CFM Metal-Fax Ltd.,
Unit 2D, Eastlands Ind. Est.,
Leiston,
Suffolk. IP16 4LL
Tel. (0728) 832353/833076

SERVICE BULLETINNO. 7DATE 10.6.90CFM METAL-FAX LTD CONSIDERSCOMPLIANCE -

SUBJECT SOLAR HEATING OF UPPER WING SURFACES COLOURED OTHER THAN WHITEMODELS AFFECTED SHADOW SERIES B, B-D, C, C-D,
STREAK SHADOW SERIES S-A1, S-ASERIAL NOS. AFFECTED ALL SERIAL NUMBERSCOMPLIANCE TIME IMMEDIATEPURPOSE

SERVICE BULLETIN N° 7

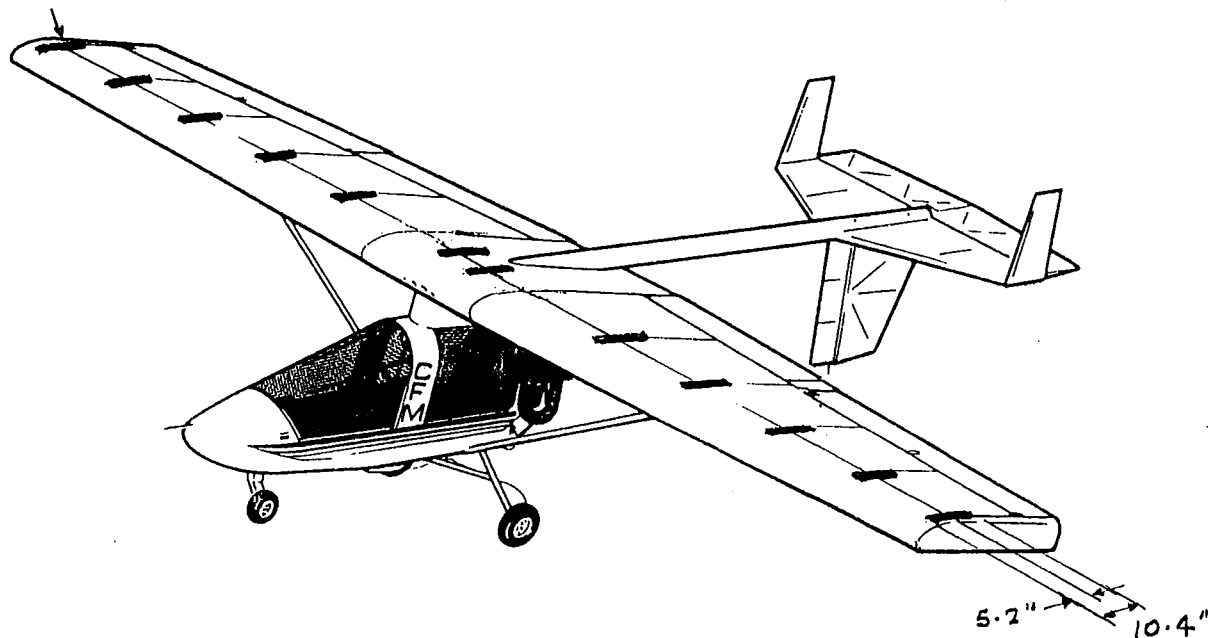
ON UPPER WING SURFACES ONLY, AT 'D' BOX TO TRAILING RIB JUNCTURE, APPLY WHITE PAINT /REFLECTIVE STRIPS (10.4" LONG) EQUALLY SPACED, FORE AND AFT TO 'D' BOX SKIN AND THE TOP OF THE TRAILING RIB. ENSURE SURFACE IS FREE FROM DUST, DIRT OR GREASE BEFORE APPLYING STRIPS.

2" STRIP REFLECTIVE ALUMINIUM TAPE
(12) PLACES

ALUMINIUM FOIL REFLECTIVE TAPE, REF. 6930, 50mm x 3.2m (MANUFACTURED BY 3M) OR WHITE PAINT
